SERVICE INFO

Assembly instructions for LuK RepSet® 624 3200 09 and 624 3200 34

Manufacturer: Renault

LuK RepSet®: 624 3200 09
624 3200 34

Image 1: Clutch disc with plastic ring

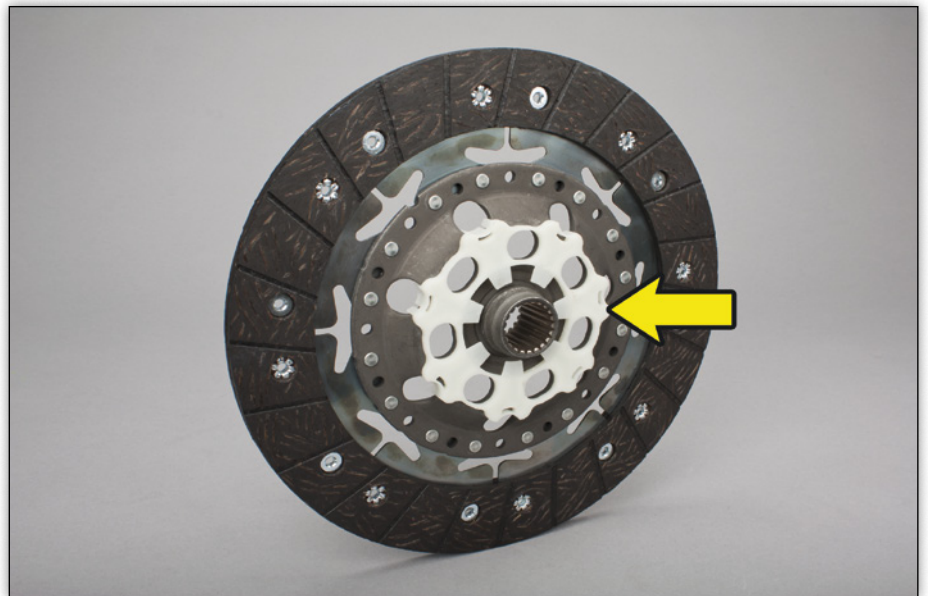
A DFC (Damped Flywheel Clutch) is installed ex works in the vehicles mentioned above. The DFC is an upgrade of the dual mass flywheel. In the DFC, the clutch disc, clutch pressure plate, crankshaft screws and dual mass flywheel are combined in one compact module. To simplify the process of fitting it to the engine in series production, the clutch disc is equipped with a plastic ring. The purpose of this ring is to hold the crankshaft screws in the holes in the DFC.

Clutch discs without a plastic ring were generally included in previous LuK RepSets®. Depending on the frequency of repair, either clutch disc version may therefore be installed in the vehicle.

Schaeffler Automotive Aftermarket now only includes clutch discs with a plastic ring in LuK RepSets®.

The plastic ring has no influence on the function of the clutch!
It can be left installed or can equally be removed!
